WATER TREATMENT PLANT EXPANSION

BOWLING GREEN MUNICIPAL UTILITIES

ADDENDUM NO. 4

ISSUE DATE: November 12, 2018
BID DATE: November 15, 2018

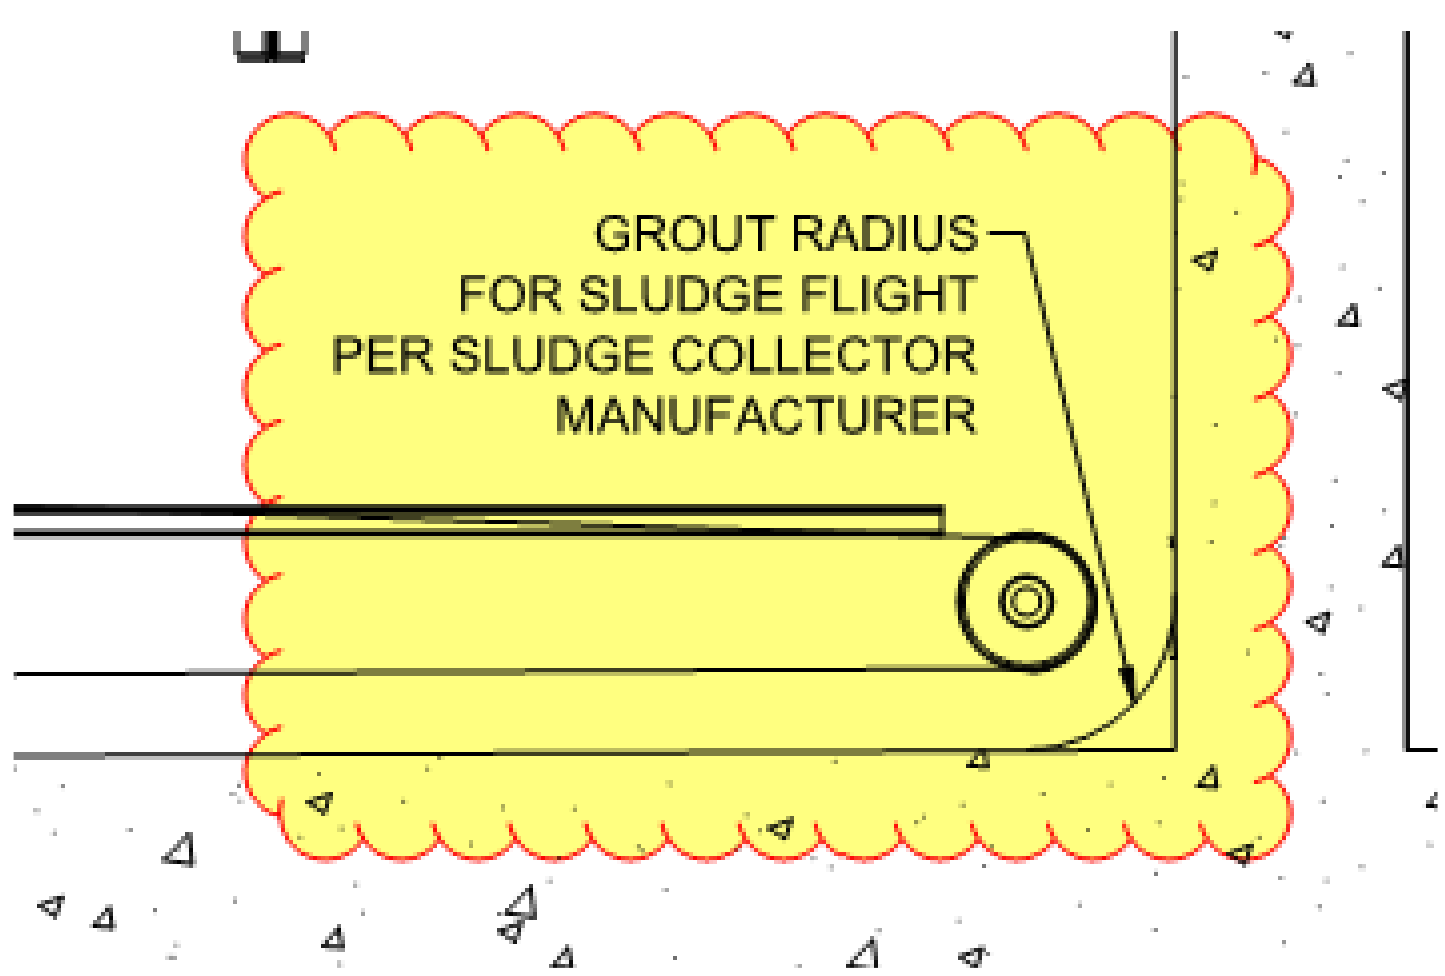
120.	Section D on drawing D3.1-08 shows a grouted fillet at the sludge collector. Can you provide a structural detail for this condition?
